## Historic District Review Committee

### Staff Report July 13, 2009

**CAPP 2009-0009 Bluemont Community Center: Renovation and Rear Addition in the Bluemont Historic District. MCPI 632-15-4042.**

**Photo 1:** Detail of proposed stone veneer, Eldorado Stone: Verona Hillshade. Source: <http://www.eldoradostone.com/flashsite/>

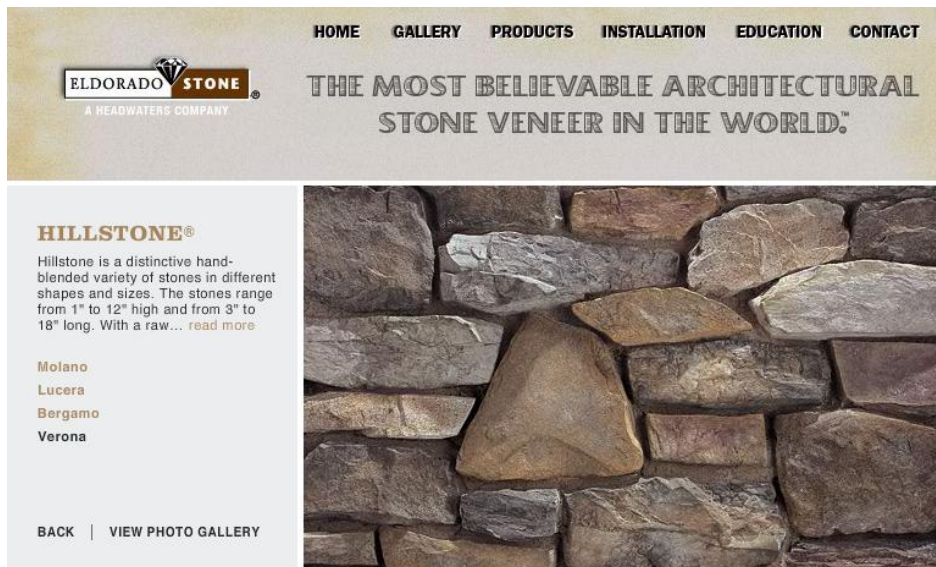
The foundation for the addition will be concrete with an imitation stone veneer. It will match the height of the stone foundation on the existing historic building. The proposed stone veneer will be manufactured by Eldorado and Verona Hillstone with "over-grout" is proposed (Photos 1 and 2). Distinguishing the foundation from the rest of the building meets the ABOT Guidelines for new construction. Cladding the foundation with an approved stone veneer on all elevations of the addition also meets the guidelines. The proposed stone veneer appears to be similar to the color, texture, shapes, and sizes of the existing stone foundation (Photo 3). Staff requests that the applicant bring a sample of the product to the HDRC meeting to evaluate whether the proposed veneer is an appropriate substitute material (ABOT Guidelines, Guidelines for New Construction: Foundation, Guidelines 1-4, and 6, pg. 77; Guidelines for Materials: Stone and Brick, Guideline 7, pg. 129).

The mortar should match the color, material, texture, joint size, and tooling of the historic building mortar (ABOT Guidelines, Guidelines for Materials: Stone and Brick, Guideline 2, pg. 129). The existing mortar has a tooled, flat bead joint. "Over-grout" is the proposed mortar joint, which will be tooled by masons to match the existing mortar joints. Additionally, the mortar will match the color, and texture of the existing foundation mortar.

1. Repair or replacement of existing windows follows the Guidelines for Windows.
2. The fiber cement clapboard has a 5” to 7” reveal.
3. If real stucco is affordable, it should match the existing stucco in appearance.
4. The imitation stone is similar in color, texture, shape, and size to the existing stone foundation.
